ROF 1 ARDF 2m receiver

ROF 1 – Change note

Covers R3.1.

Change note upgrade to R3.2

Change note 1

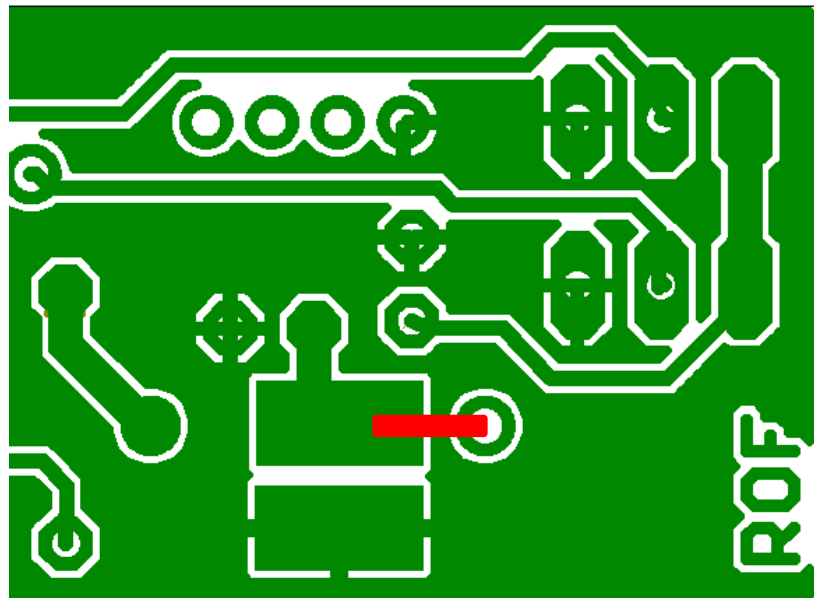
VBAT power not connected from pad to the internal signal.

Connect pad on the solder side of the board to the pin of the D2 pin as shown.
